TRI-PARTY AGREEMENT

Change Notice Number TPA-CN- 0772	TPA CHANGE NOTICE FORM	Date: 7/16/2019
Document Number, Title, and Revision: DOE/RL-2000-41, Interim Action Waste Management Plan for the 100-NR-2 Operable Unit, Rev. 1		Date Document Last Issued: August 2000
Approved Change Notices Against this Document: TPA-CN-256, TPA-CN-200, TPA-CN-231, TPA-CN-244, TPA-CN-301, TPA-CN-302, TPA-CN-312, TPA-CN-636, TPA-CN-699		
Originator: S.M. Sexton		Phone: 373-2285

Figure 2. The 6265A Building Location.

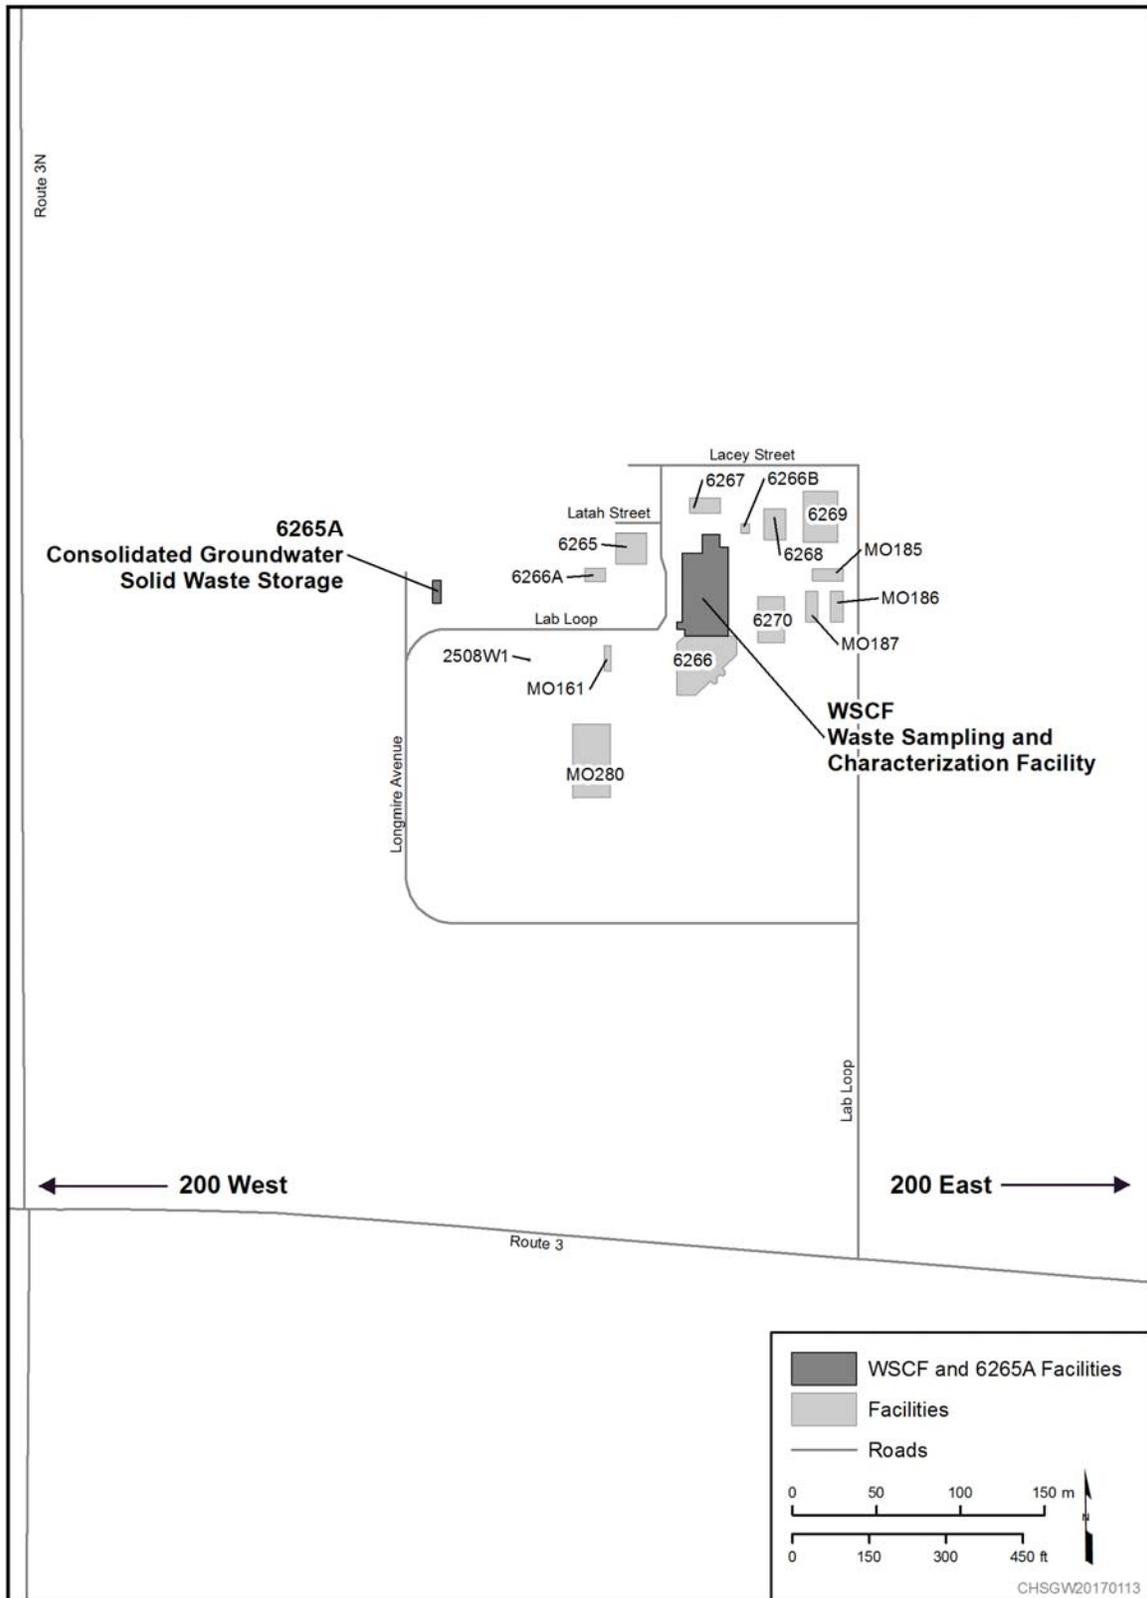
Addition of a consolidated groundwater solid waste complex in the Central Plateau to the approved IDW storage locations. Added figures showing the location of the 6265A Building for identification.

Added two new figures to DOE/RL-2000-41 to show the location of the new consolidated groundwater solid waste complex at the 6265A Building located in the Central Plateau, as well as the outside of the building for identification.

The addition of a centrally located storage location will add efficiency to the management of IDW that is generated in the 100-NR-2 Groundwater Operable Unit. Figures 2 and 3 were added to show the location and identity of the 6265A Building.
